City of Phoenix

ADDENDUM A

Staff Report Z-42-23-7

*REVISED November 1, 2023

*Revised Conceptual Site Plan date stamped November 1, 2023

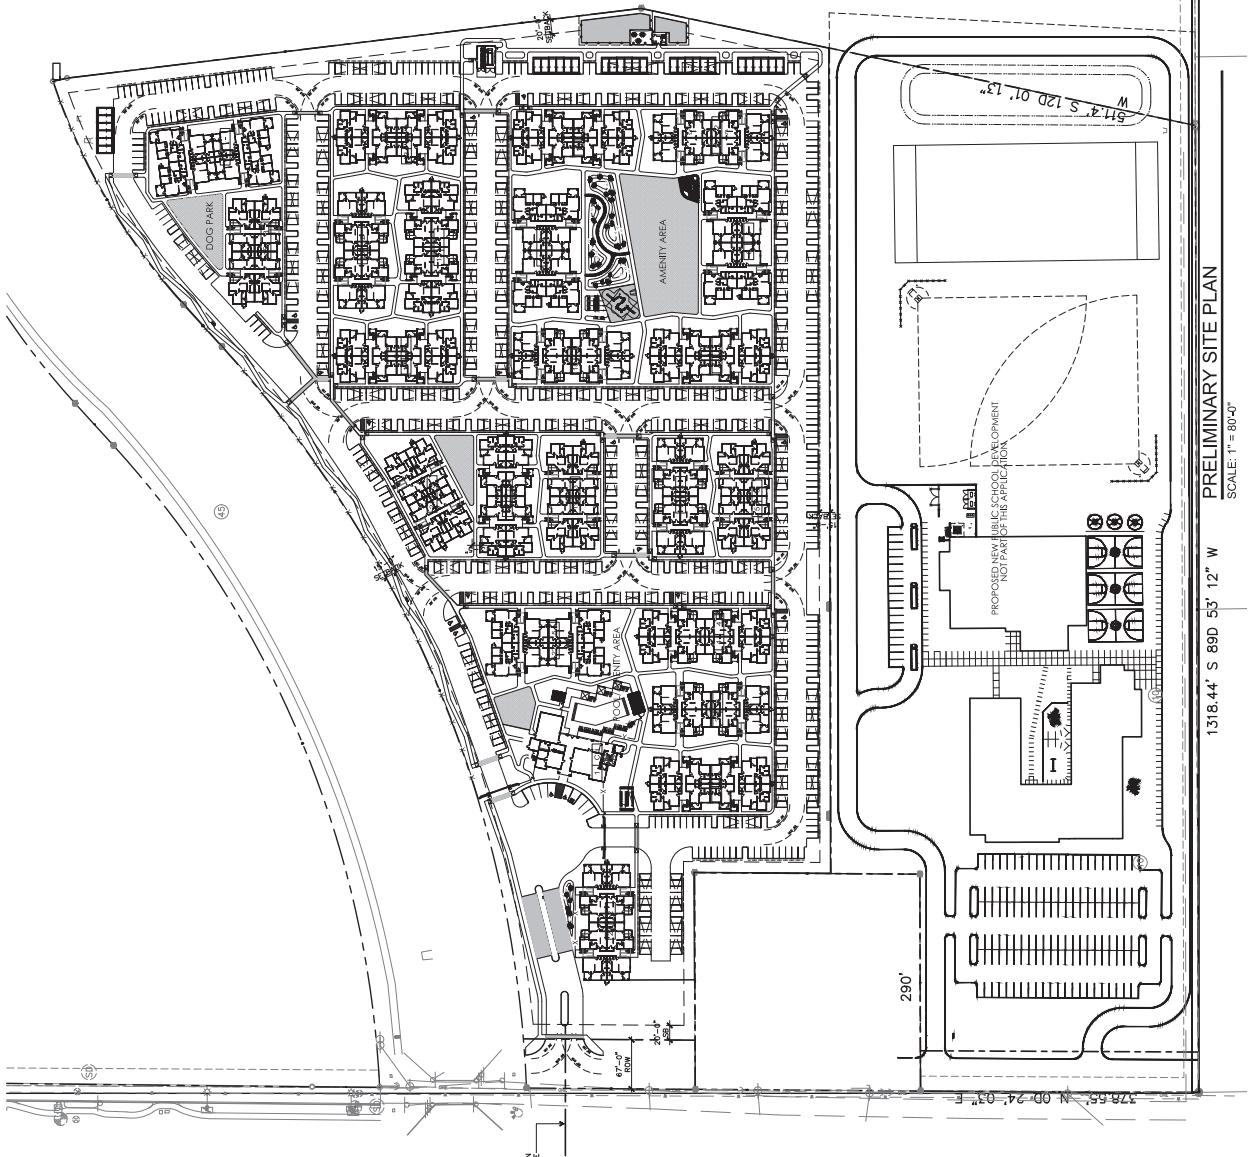
On October 16, 2023 the Laveen Village Planning Committee (VPC) heard this request and recommended approval, per the staff recommendation with modifications and additional stipulations. Stipulation No. 3 was added to require general conformance to the revised site plan to be submitted by the applicant after the *meeting. The applicant has since submitted a revised site plan on November 1, 2023 that meets the required building setbacks when adjacent to the Loop 202 Freeway.

- *3. THE MULTIFAMILY DEVELOPMENT SHALL BE IN GENERAL CONFORMANCE ~~TO THE FUTURE SITE PLAN SUBMITTED BY THE APPLICANT WITH THE SITE PLAN DATE STAMPED NOVEMBER 1, 2023, AS MODIFIED BY THE FOLLOWING STIPULATIONS AND APPROVED BY THE PLANNING AND DEVELOPMENT DEPARTMENT.~~
